Re: Aurora State Airport Master Plan Proposed Preferred Alternative Use of Modifications of Standards

**Aurora State Airport (UAO)
Proposed Modification of
Runway Object Free Area (ROFA) Design Standards**

October 5, 2024

UAO Figure B: Runway CL to Airport Perimeter Fence
Figure AA-31. Missed approach collision risk for ADG II Cat I.

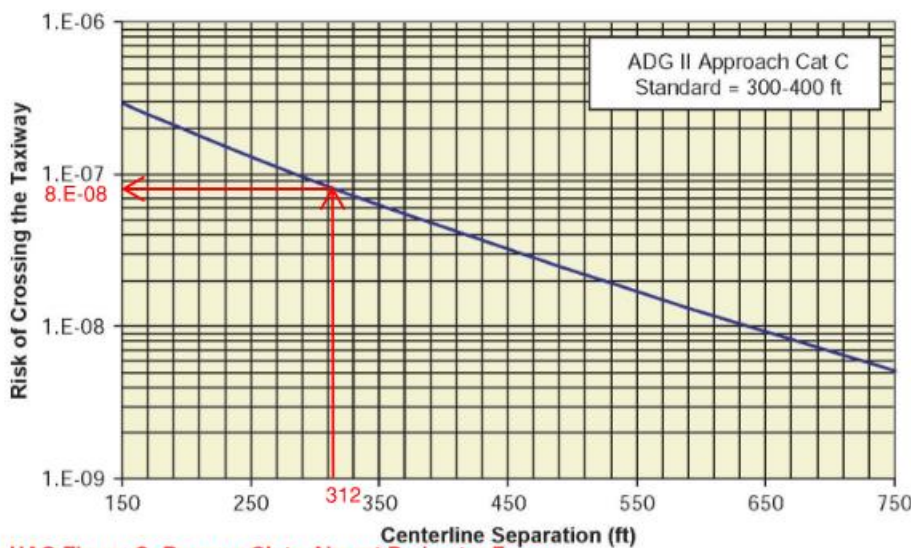
1. Airborne Landing Phase Risk from Reduced ROFA – For a very conservative analysis we will assume that this includes all approach to landings, not just missed approaches. Using the separation of 312' and Figure AA-33 in Appendix A of ACRP Report #51, the following provides a risk level 6.0E-11 of occurrence per landing (which as an inverse, is one chance in a 16.7 trillion landings) that an aircraft gets 312' from the runway centerline. This can be seen in the figure below:

The current annual number of landing operations at UAO is approximately 45,115 or half of the 90,230 annual operations. As the risk is one incident in every 16.7 trillion landings, the time between occurrences is calculated as 16 trillion landings divided by 45,115 landing operations per year which equates to one incident every 369,000 years. Thus, this risk is of no significance.

UAO Figure C: Runway CL to Airport Perimeter Fence
Figure AA-42. Landing veer-off collision risk for ADG II.

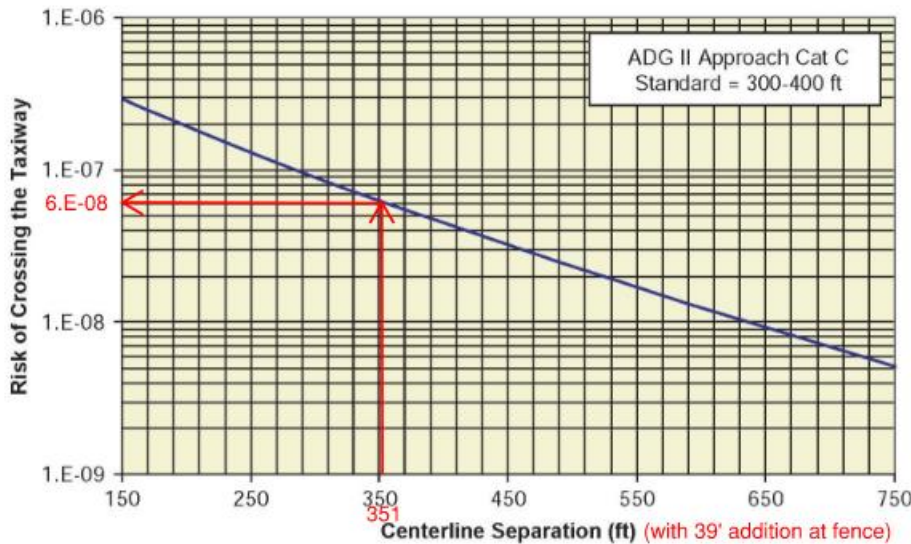
2. Landing Roll Phase Risk for Reduced ROFA - Using the separation of 312' and Figure AA-43 in Appendix A of ACRP Report #51, provides a risk level $8.0E-08$ or in the inverse: one chance in 12.5 million landings. This can be seen in the figure below:

As the risk is one incident in every 12.5 million landings, the rate of occurrence is calculated as 12.5 million landings divided by 45,115 landings per year which equates to one incident every 277 years.

Figure AA-42. Landing veer-off collision risk for ADG II.
UAO Figure D: Runway CL to Airport Perimeter Fence Including Wingspan adjustment

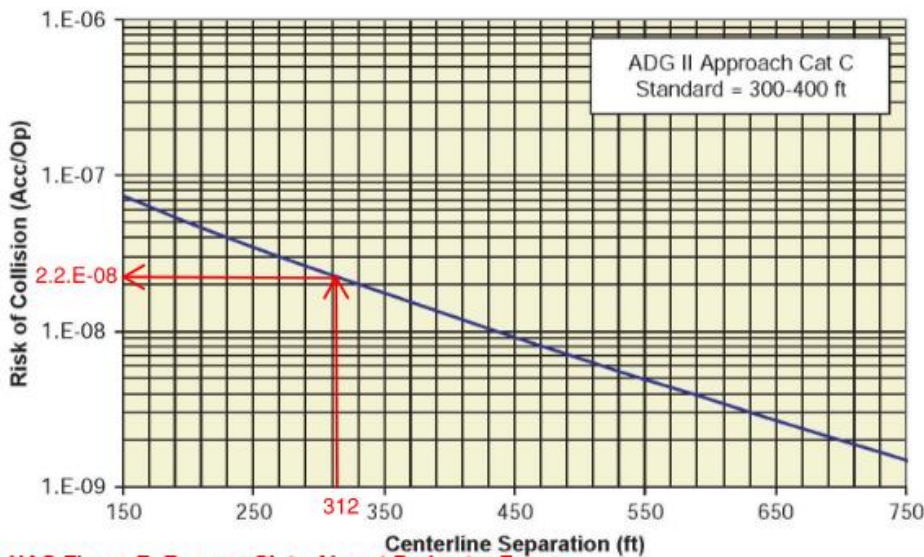
Using the ACRP described adjustment when the object is not another aircraft and half the C-II wingspan can be added to the clearance distance, results in a separation of 351' and Figure AA-43 in Appendix A of ACRP Report #51, provides a risk level $6.0E-08$ or one chance in 16.7 million landings. This can be seen in the figure below:

As the risk is one incident in every 16.7 million landings, the rate of occurrence is calculated as 16.7 million landings divided by 45,115 landings per year which equates to one incident every 369 years.

UAO Figure E: Runway CL to Airport Perimeter Fence
Figure AA-49. Takeoff veer-off collision risk for ADG II.

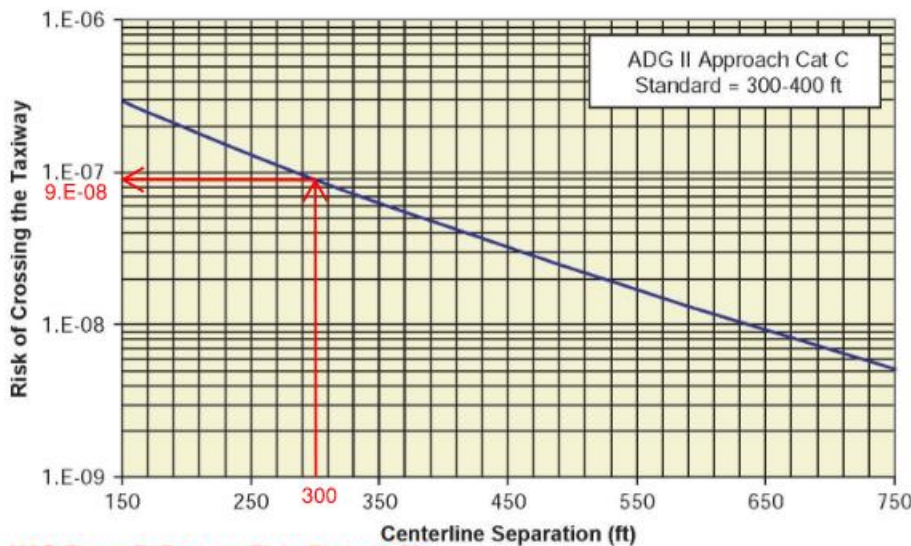
3. Takeoff Roll Phase Risk for Reduced ROFA - Using the separation of 312' and Figure AA-49 in Appendix A of ACRP Report #51, provides a risk level 2.2E-08) or one chance in 45.5 million takeoffs. This can be seen in the figure below:

As the risk is one incident in every 45.5 million takeoffs, the rate of occurrence is calculated as 45.5 million takeoffs divided by 45,115 takeoffs per year which equates to one incident every 1,008) years.
